**CITY OF AUSTIN
Board of Adjustment
Decision Sheet**

CASE NUMBER: C15-2020-0020

ADDRESS: 1401 3RD ST

VARIANCE REQUESTED: The applicant is requesting a variance(s) from Section 25-2-492 (Site Development Regulations) from setback requirements to decrease the minimum interior side setback from 5 feet (required) to 2.77 feet (requested) in order to complete a Single-Family residence in an "SF-3-NP", Single-Family Residence-Neighborhood Plan zoning district. (East Cesar Chavez Neighborhood Plan)

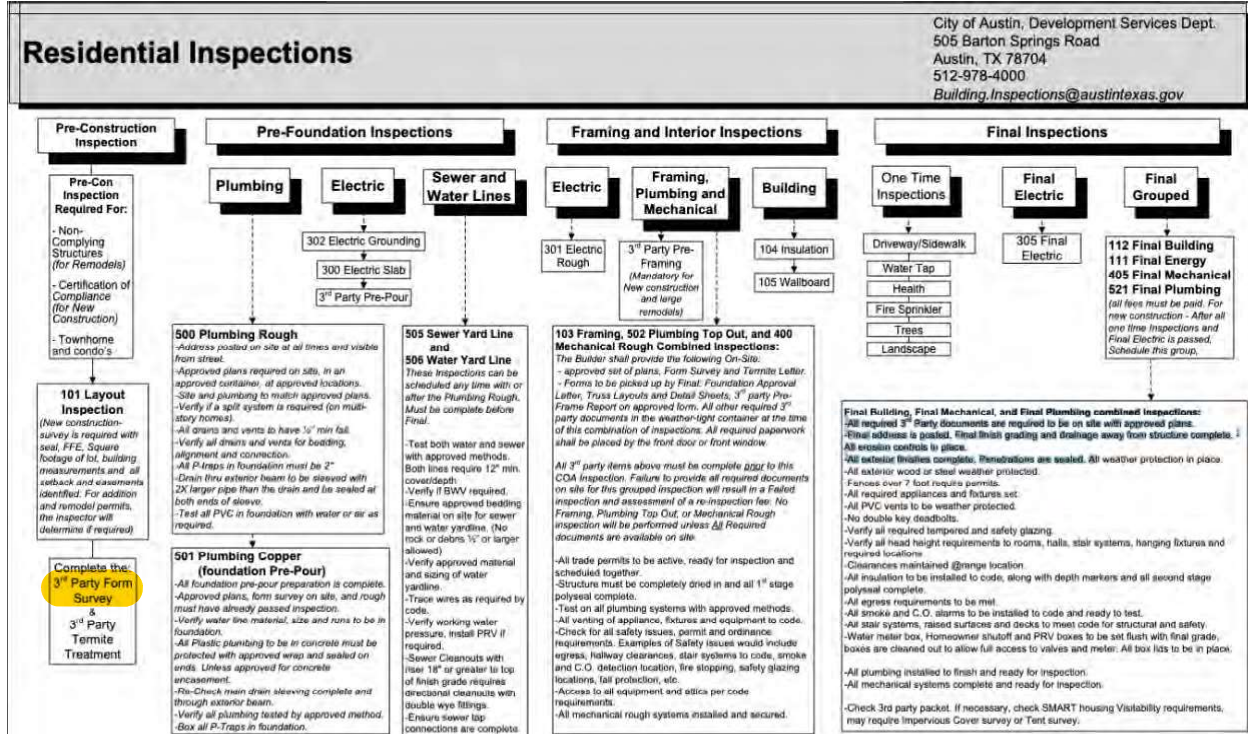
- **82 inches.** At the northeast corner of the structure, the as-built clearance between 1401 E 3rd Street and the abutting historic structure at 1403 E 3rd Street is 82” (6’-10”). The City’s official side-lot setbacks call for 10’ of clearance; the as-built clearance is 68% of what is required.

- **43 inches.** As currently built, the width of the first-floor entrance sidewalk is 43”. Since the fence between properties is not on the lot line, this clearance is not guaranteed going forward.

- **18 inches.** The approximate distance that the existing fence built by Durham Trading Partners encroaches on the abutting property at 1403 E 3rd Street is 18”. Note that the existing sidewalk straddles over the lot line by approximately 10”.

- **33 inches.** If the abutting property owner ever moves the fence to the lot line, the width of the first-floor entrance sidewalk will be reduced to a non-ADA-compliant width of 33”.

In practice, the as-built clearance is already quite tight and restricted. If the abutting property owner ever moves the fence to the property line—as is common during redevelopment activities—the sidewalk clearance will decrease from the existing 43" to a non-ADA-compliant width of 33" (2.78 feet).
